PLANNING COMMISSION REGULAR MEETING AGENDA

Wednesday, May 27, 2026
7 p.m.

5. **P26-0360 and PUD-152, 231 Old Bernal Avenue**- Applications for: (1) Planned Unit Development (PUD) Rezoning (P26-0360) to rezone the subject parcel from MU-T (Mixed Use-Transitional) District to PUD-MU-T (Planned Unit Development-Mixed Use-Transitional) District; (2) Certificate of Appropriateness to demolish an existing 6,160-square-foot commercial office building in the Downtown Revitalization District; and (3) PUD Development Plan (PUD-152) to construct a three-story, four-unit residential building on a 0.49-acre lot, with units ranging in size from 430 square feet to 13,626 square feet and associated site improvements located at 231 Old Bernal Avenue (APN: 94-156-21). The project is exempt from the California Environmental Quality Act (CEQA) pursuant to Public Resources Code Section 21080(b)(5) and CEQA Guidelines Section 15270, which statutorily exempt projects that a public agency intends to deny.

C4.0

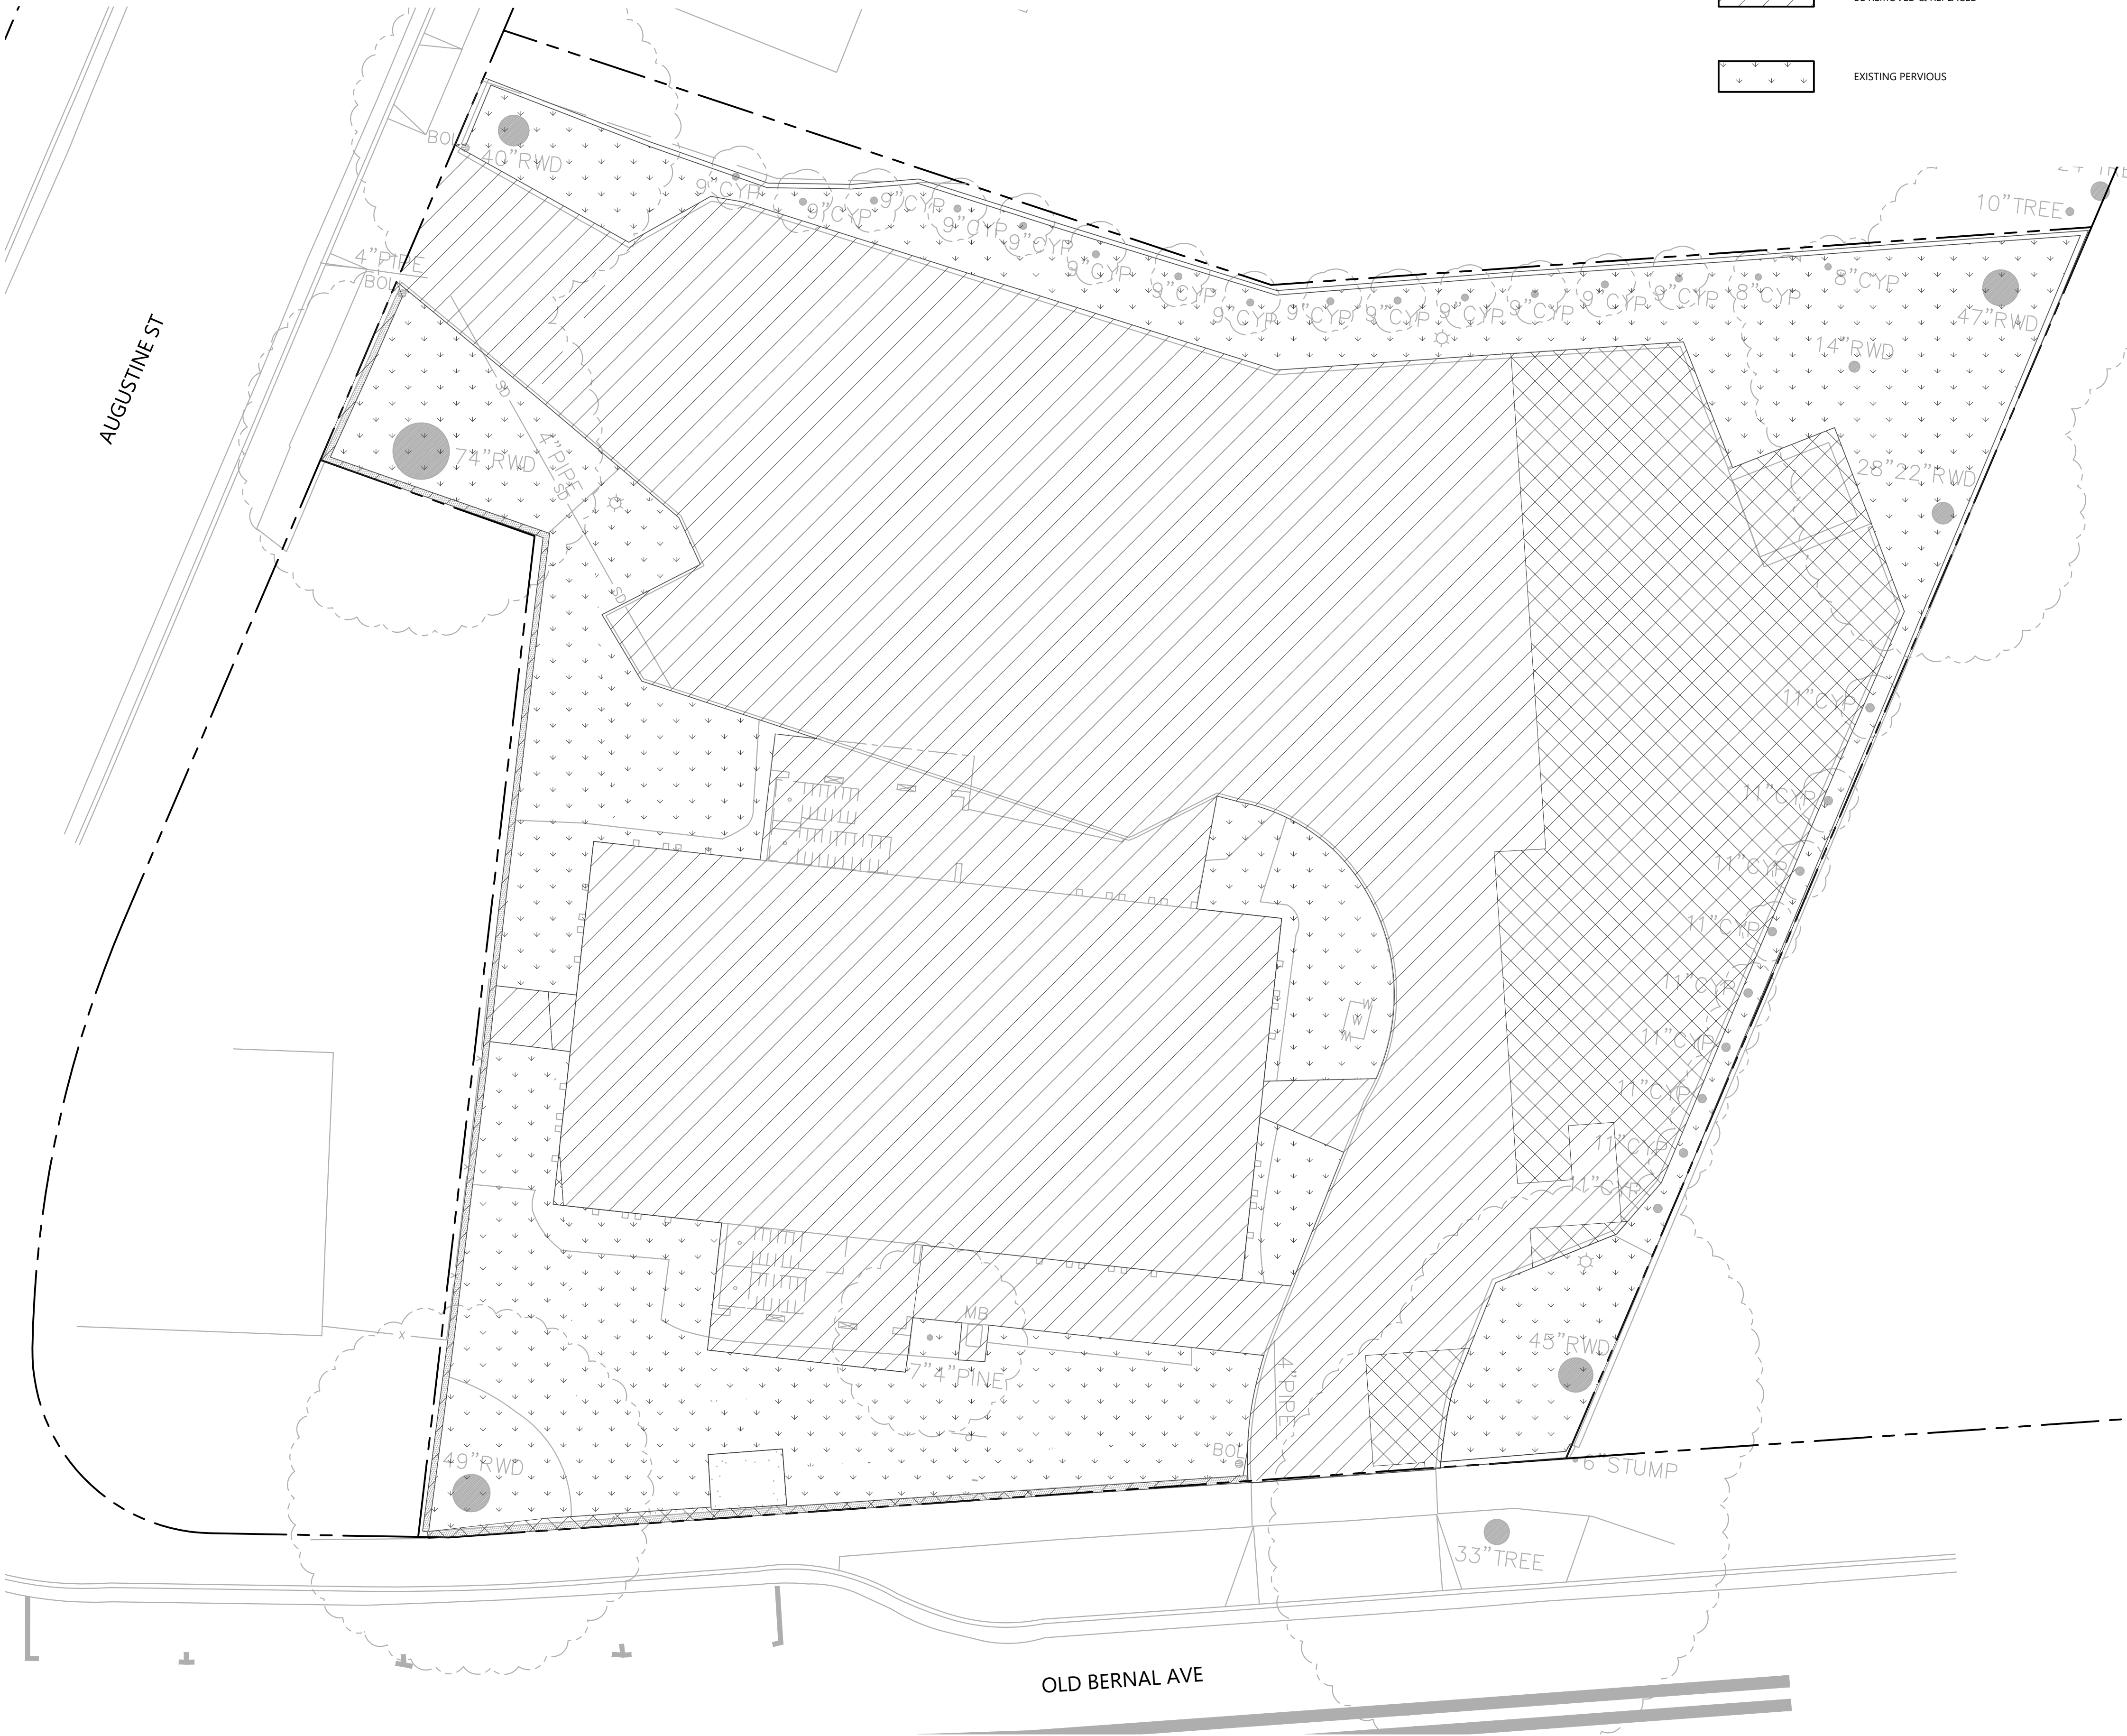
- e. **RESOLVED.**
 - f. **NEW COMMENT.** Sheets C4.0 & C5.1 show flow through planter #5 within the revised PSE. The design plans shall be revised to show stormwater treatment features outside of the PSE but still sized to ensure the proposed 4% sizing method per the Technical Guidance Manual.

- g. **NEW COMMENT.** Sheet C4.0 shows a permeable pavement overflow underdrain along the sidewalk transition on the south side of the driveway. Provide clarification on this note. The overflow should connect to the proposed storm drain and flow into the storm drain manhole.

- h. **NEW COMMENT.** Sheet C4.0 shows a note to connect to ex. SDMH but also proposes a new storm drain manhole. Provide clarification on this conflict and where the proposed storm connection is.

- a) **AMENDED COMMENT.** Sheet C4.0 shows a new driveway and sidewalk. Reference City of Pleasanton Standard Drawing 106 reference on the plans. *Applicant response was that a modified driveway entrance has been called out and City Standard Drawing 106 will not work. The proposed modified driveway with a 1.5% cross slope is flat (1.4 to 1.9" from FL to top of driveway approach) and will introduce potential ponding on Augustine Street. The nearest drain inlet is close to corner of Augustine and Bernal. The plans shall be revised to address these issues.*

4. **STORM DRAIN DESIGN:** Per Sheet C4.0, there is a proposed storm drain manhole on Augustine Street. Include the City standard drawing 205 reference to the plans.
(Address this condition prior to plan approval)
